CITY OF PORTLAND, MAINE

SITE PLAN REVIEW

RE: #295-D-3, 4, & 5 Avalon Road

Your application to construct a single family dwelling, 26' x 32', two story cape style, has been reviewed, and a building permit is here-with issued subject to the following requirements.

SITE PLAN OF LOTS 41, 42, &

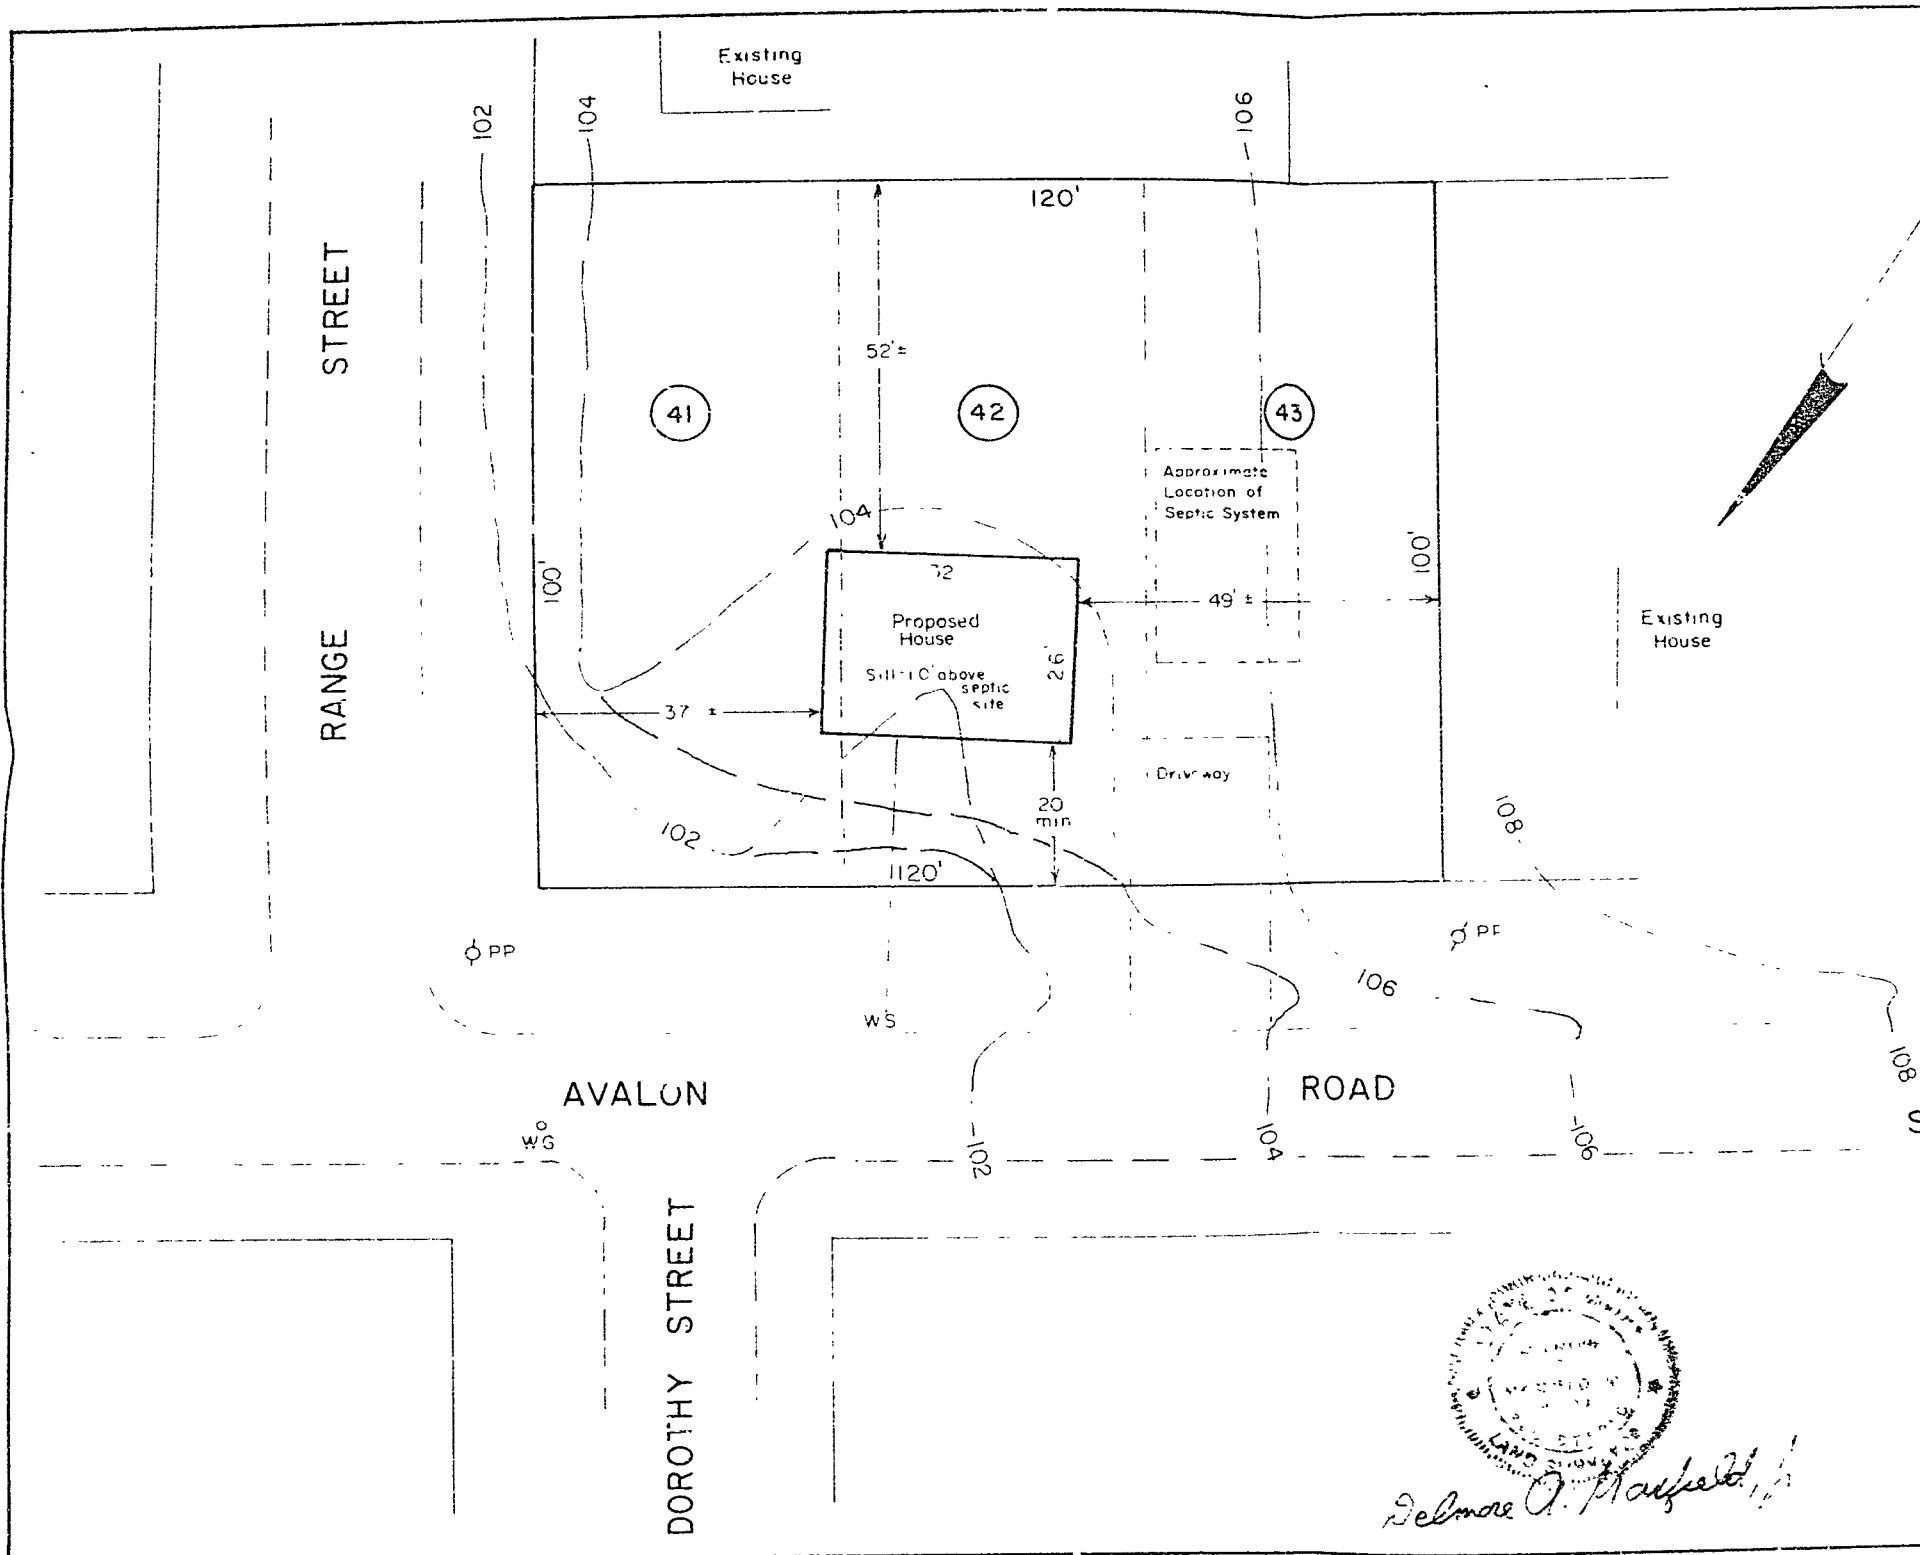
- 1) Under the required Site Plan Review a Class "A" survey is needed for review. Consult Malcolm Ward in this office for further particulars.
- 2) The local Plumbing Inspector must give an approval prior to permit issuance on the septic system. Consult Erno Goodwin in this office for particulars. 9
- 3) More detailed plans are needed as following:
 - a) More frost wall information is needed such as how far below grade it will extend. *on Lot 2*
 - b) A cross section plan showing the dimensions of all structural members is needed.
